# CIRNAC Comments to NIRB Re: Agnico Eagle Mines Limited's Meadowbank Complex Project 2024 Annual Report

Your file - Votre référence  
03MN107 and 16MN056  
Our file - Notre référence  
GCdocs# 138849829

**Re: Comment Request for Agnico Eagle Mines Limited's Meadowbank Complex Project 2024 Annual Report**

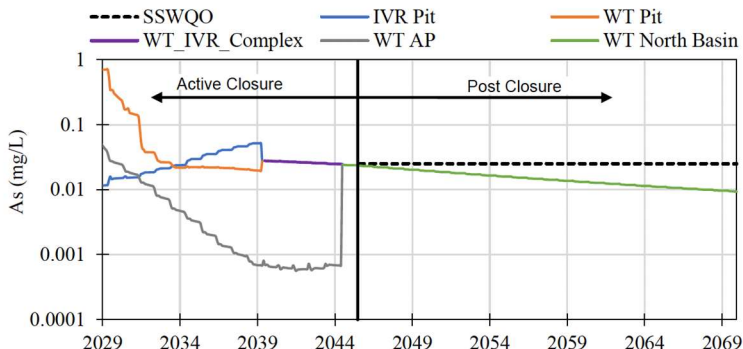
<b>Comment Number:</b>	<b>CIRNAC #4</b>
<b>Subject:</b>	Model Prediction Accuracy and Decision Making
<b>References:</b>	<ul style="list-style-type: none"> <li>• 2024 Annual Report: All sections</li> <li>• Appendix 13</li> <li>• Appendix 14</li> </ul>
<b>Background/Rationale:</b>	<p>CIRNAC draws attention to the following three example figures:</p>  <p>Figure 6-1 from Appendix 14 (Whale Tail site)</p> <p>In this case, the figure clearly demonstrates that there has been a wide range of water quality predictions throughout the evolution of the Whale Tail Project. At the right side of the figure, the current 2024 arsenic concentration predictions for the IVR Pit are approximately two orders of magnitude greater (i.e., 100x) than what was predicted in the 2019 FEIS.</p>

Comment Number:	CIRNAC #4
	<div data-bbox="581 258 1382 615"> </div> <div data-bbox="591 638 1242 669"> <p>Figure 10 from 2024 Annual Report (Meadowbank Site)</p> </div> <div data-bbox="584 686 1451 781"> <p>In this case, the figure illustrates that measured TDS concentrations in the Vault Pit are approximately one order of magnitude (i.e., 10x) greater than AEM's "poor end" prediction during the original Water Licence application.</p> </div> <div data-bbox="597 812 1414 1169"> </div> <div data-bbox="584 1190 1279 1222"> <p>Figure 11 from the 2024 Annual Report (Meadowbank Site)</p> </div> <div data-bbox="584 1239 1451 1333"> <p>In this case, the figure shows that measured arsenic concentrations in Goose Pit are two orders of magnitude (i.e., 100x) greater than the most recent ICRP water quality predictions from as recently as 2019.</p> </div> <div data-bbox="584 1350 1481 1476"> <p>Collectively, the example figures demonstrate that predictions can change significantly over time and that measured concentrations often differ by multiple orders of magnitude relative to predictions. The 2024 Annual Report and supporting documents contain numerous similar variances.</p> </div> <div data-bbox="584 1493 1481 1745"> <p>CIRNAC notes that such variances are common with predictions of complex environmental systems that can be challenging to model. In this regard, CIRNAC is not criticizing AEM's predictions; to the contrary, competent professionals perform AEM's predictions, using a large inventory of monitoring data and industry best practices. CIRNAC is, however, concerned that the uncertainty associated with the predictions has been overlooked when making some project decisions. Following is an example from the 2024 Annual Report:</p> </div>

Comment Number:	CIRNAC #4
	 <p>Figure 6-4 From Appendix 14 of the 2024 Annual Report</p> <p>In this instance, arsenic concentrations in Whale Tail Lake are predicted to equal the Site-Specific Water Quality Objective (SSWQO) in 2044. On that basis, AEM indicates that it will reconnect the pit lake to the receiving environment, and the post-closure phase will begin immediately afterward. Taking into consideration the uncertainty associated with model predictions (as noted above), CIRNAC considers it not a safe practice to make closure decisions without any “margin of error”. The additional information is necessary to verify AEM’s conclusion that their modelling results are conservative and over-predict any potential impacts. Results from past predictions demonstrate that this is not the case. CIRNAC’s position is that closure decisions should be based on a more conservative set of assumptions regarding future water quality, taking into account the accuracy of past predictions.</p>

<b>Recommendation:</b>	CIRNAC recommends that AEM perform quantitative sensitivity analyses of their water quality predictions. The analyses should quantify potential variability in all major source terms and associated pathways (e.g., elevated arsenic seepage from pit walls, waste rock storage facilities (WRSFs) and mine areas). CIRNAC acknowledges that some sensitivity analyses have already been performed in prior predictions, but a more comprehensive analysis of all variables is justified.
